Addendum No 002 Narrative

To Drawings and Specifications dated October 31, 2023

Walnut Grove Intermediate School – Science Classroom Modernization ***West Covina Unified School District***

PBK Project No.: 202117
DSA A#: A# 03-123048
DSA File No.: 19-110

20 ENLARGED RAMP
1/4" = 1'-0"

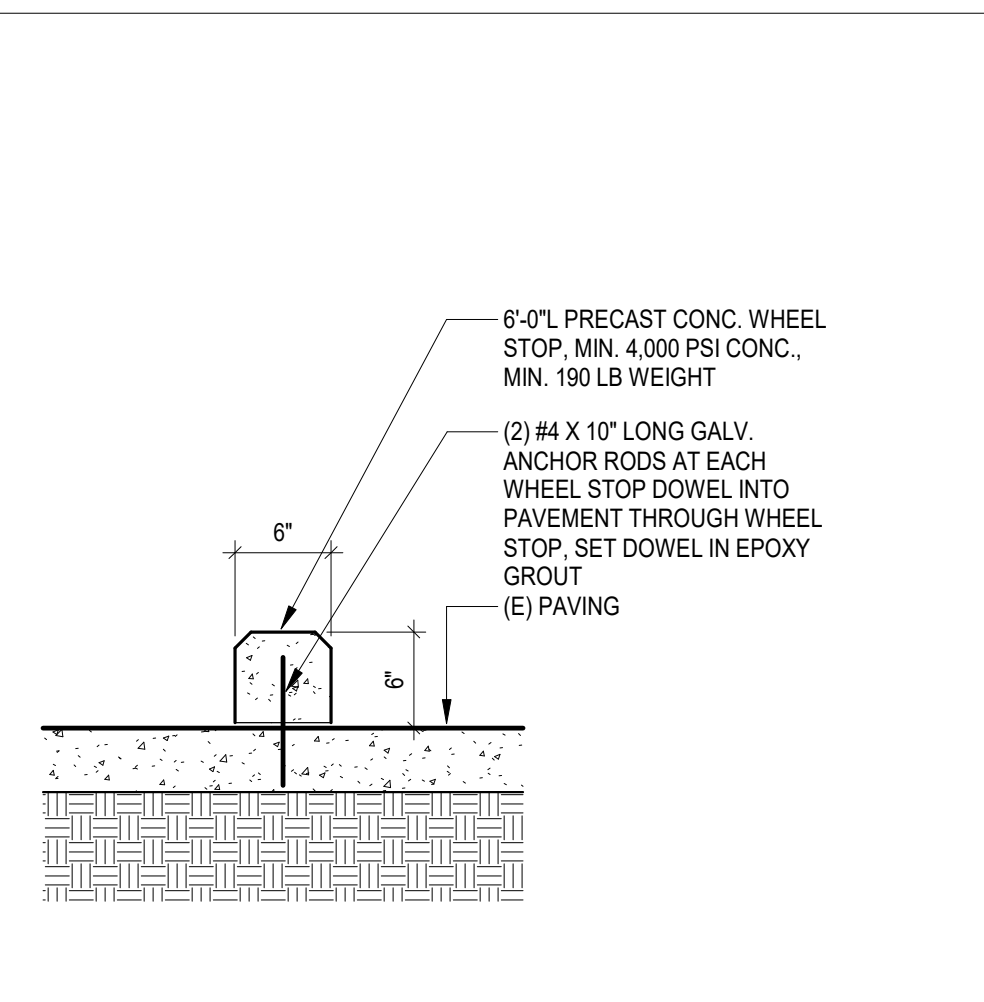
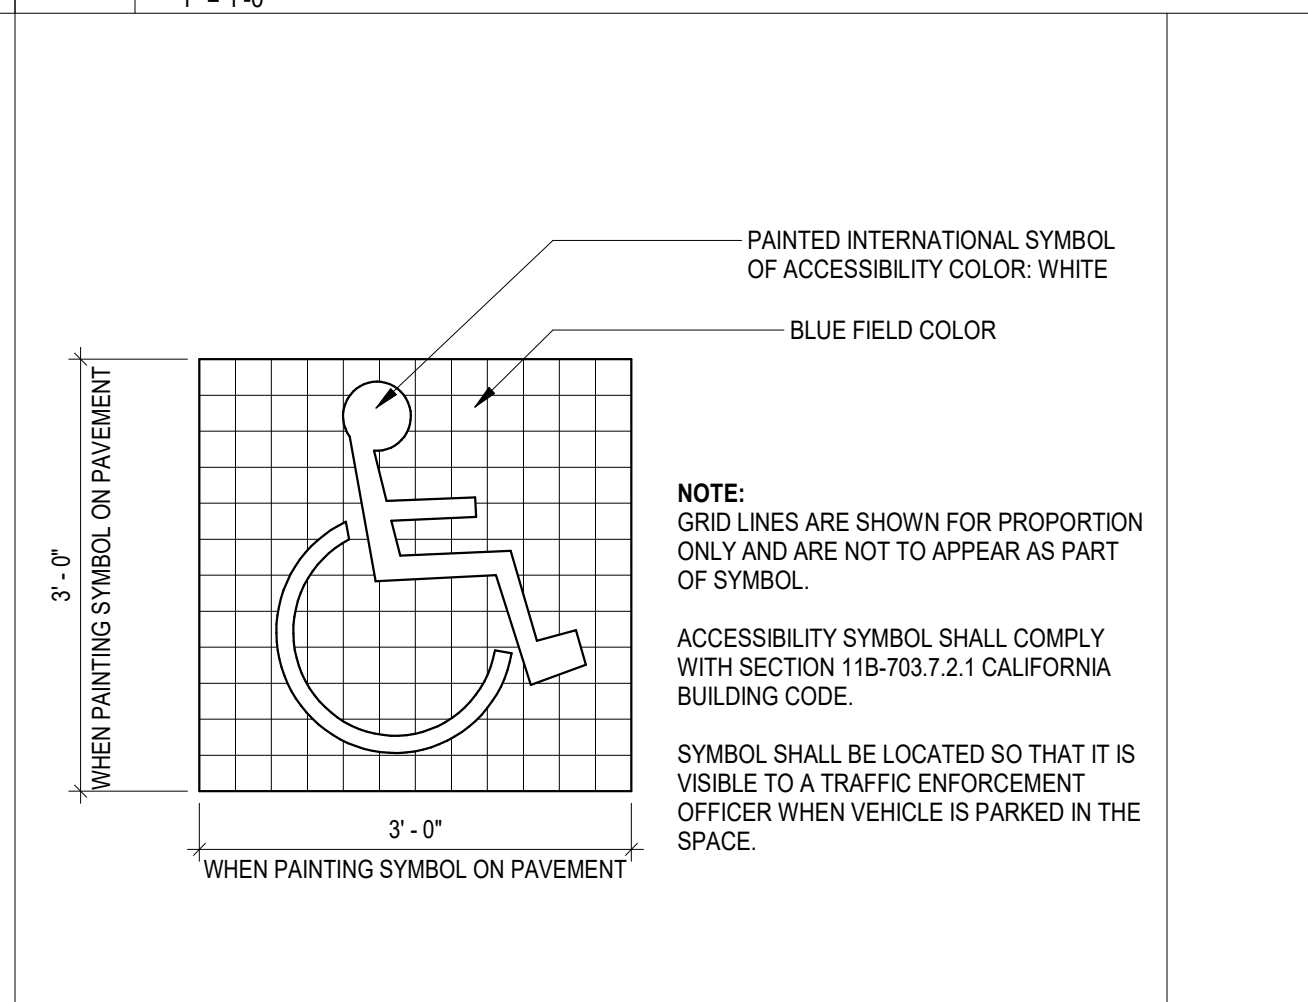
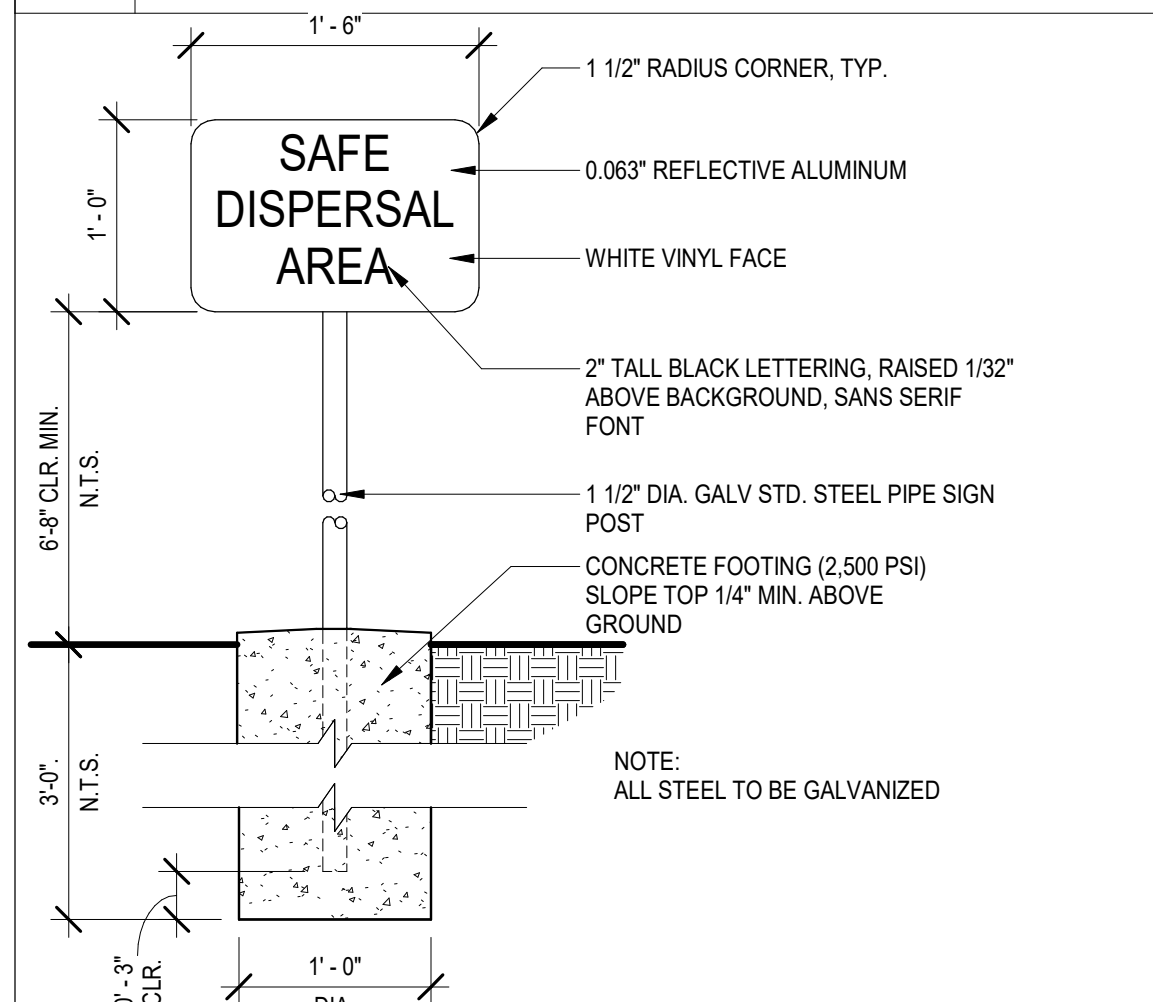
1. Item No. AD2- Sheet A1.01 – Enlarged Site Plan & Site Details:
 - A) Added notes 1, 2 & 3 on detail 20/A1.01.
2. Item No. AD2- Sheet A2.01 – Overall Remodel Floor Plan – Bldg. 7:
 - A) Revised detail reference adjacent to keynote 09.01 in rooms 19 and 22 from 2/A8.02 to 4/A8.2
□and added detail reference 4/A8.2 adjacent to note 09.01 in room 18.

OVER ALL REMODEL FLOOR PLAN - BLDG. 7

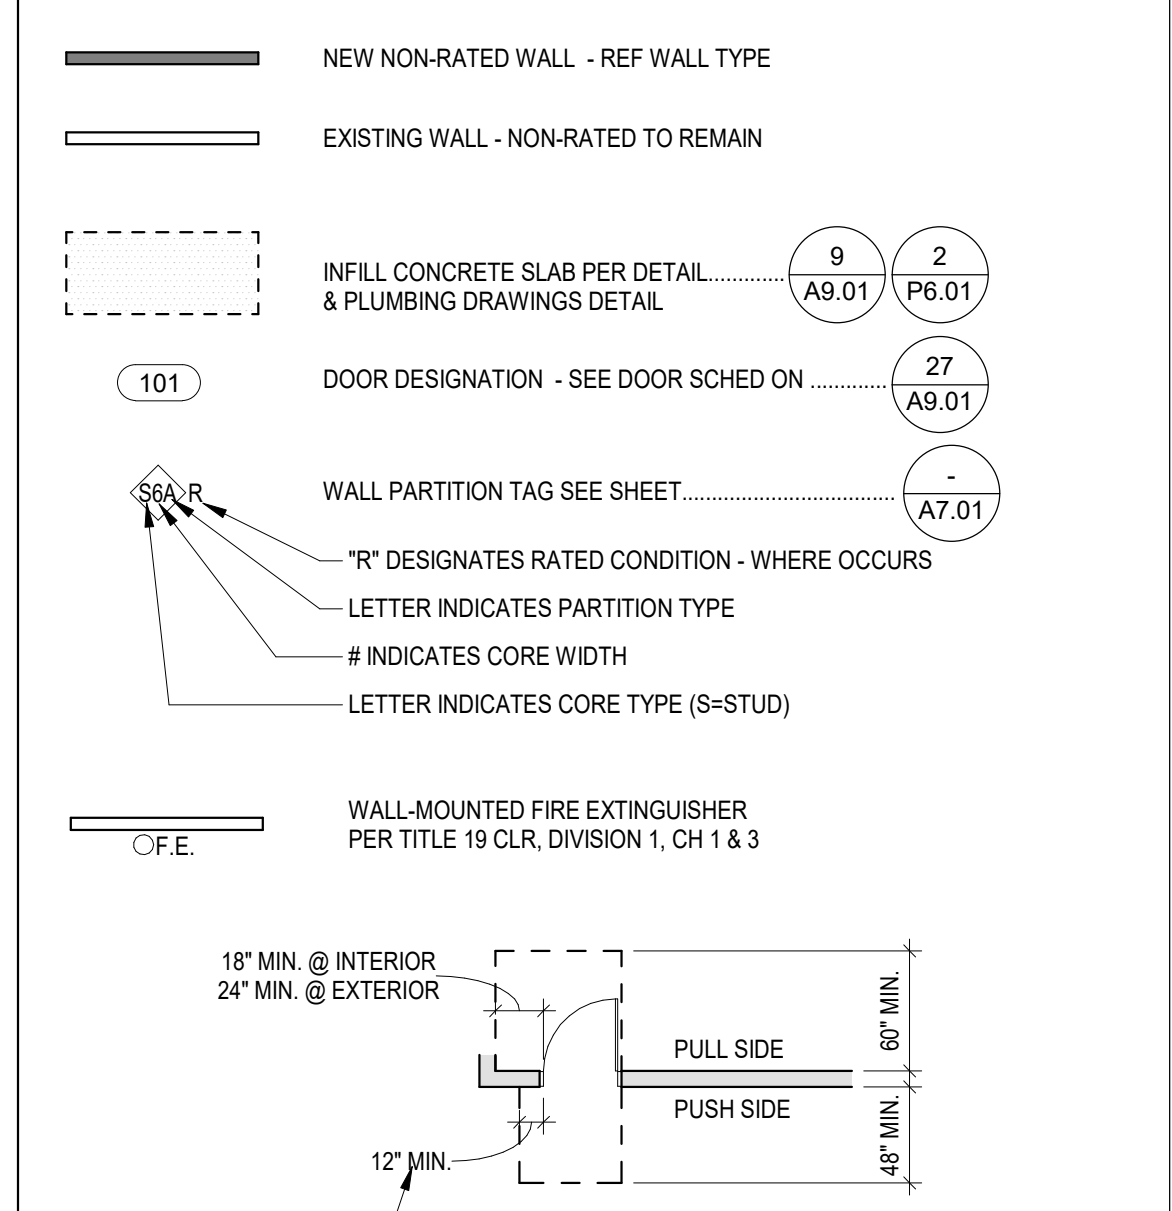
- A) **Q1** - Keynote 09.01 A/2.01 pointing to wall S3 references detail 2/A8.02 which does not describe that wall type. Please provide description for wall S3.
R1 – Revised detail reference adjacent to keynote 09.01 in rooms 19 and 22 from 2/A8.02 to 4/A8.2 and added detail reference 4/A8.2 adjacent to note 09.01 in room 18.
